## **REVISION HISTORY:**

## MCU: ESP32-WROOM-32UE-R2

JS HW			
Sheet: /MCU/ File: MCU.kicad_sch			I
Title: CDR	C - Custom DRC for Bit 10D		
Size: A4	Date: 25-11-2024	Rev: B	
KiCad E.D.A. 8.0.4		Id: 3/5	
4	5	<u>'</u>	6

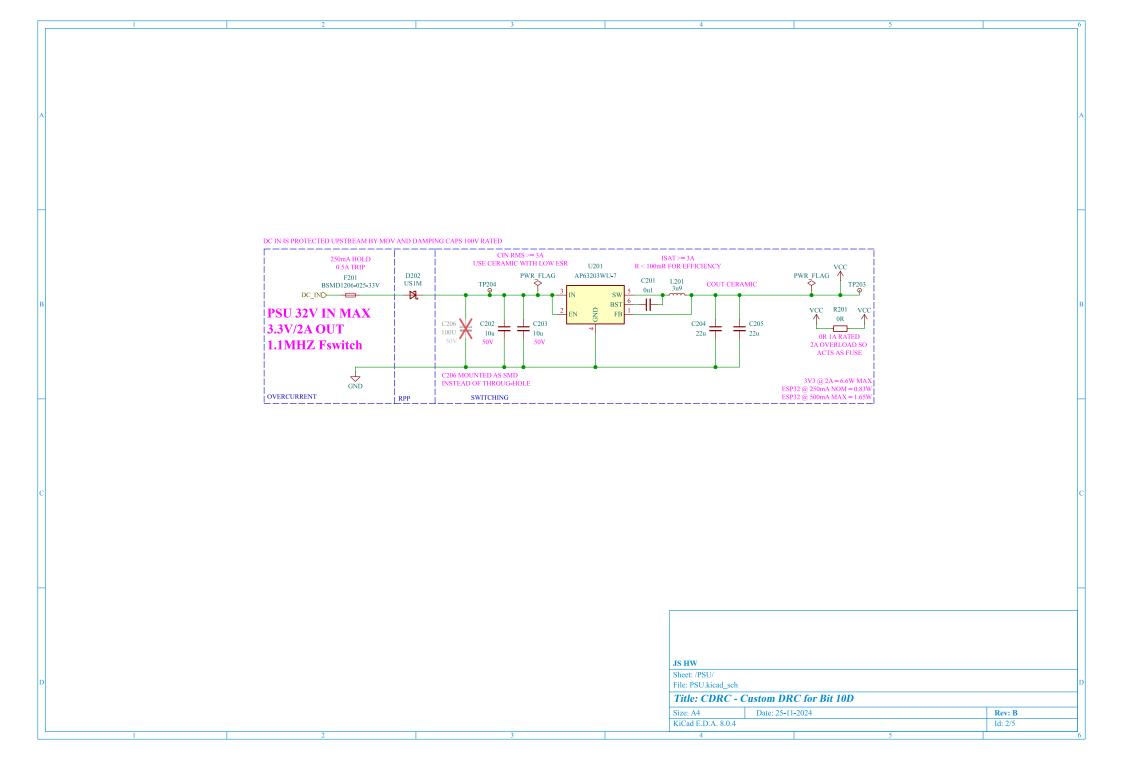
B: Changed RS485 RX connection to ESP32 from GPIO21 to GPIO27 (RTC IO) Removed solder bridge pads to control RS485\_RX\_EN. Confirmed working as intended

Overhaul PCB outline and layout
